MEMORANDUM

From:	Chief Officer, Environment & Technical	To:	Chief Officer Planning & Regulatory
		FAO:	Sharon Holman
Our Ref:	ET/DC/MZ/P/2023/0800	Your Ref:	P/2023/0800
Date:	6th September 2024

Land At, Bangor Road, Johnstown, Wrexham.

Reserved matters pursuant to outline planning permission P/2020/0210, for a mixed use residential, business, industrial, storage and distribution and retail development (appearance, landscaping, layout and scale)

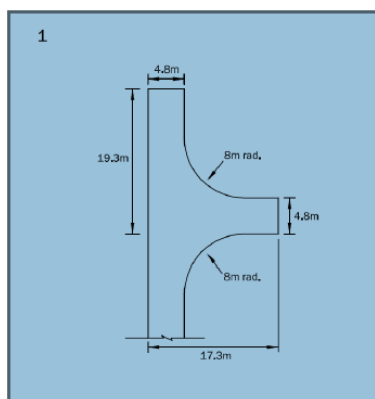
Vehicle tracking of all turning areas should be provided to indicate that refuse vehicles can safely turn within the site. From a review of the plans provided it is likely that many fall below the Wrexham's standard detail for adoptable turning heads and that some will likely rely on the use of unadopted areas to make turning manoeuvres. The applicant should demonstrate compliance with Wrexham's standards and that refuse vehicles can turn safely without the use of unadopted land. Many of the turning heads shown fall short of the WCBC turning head standards shown below.
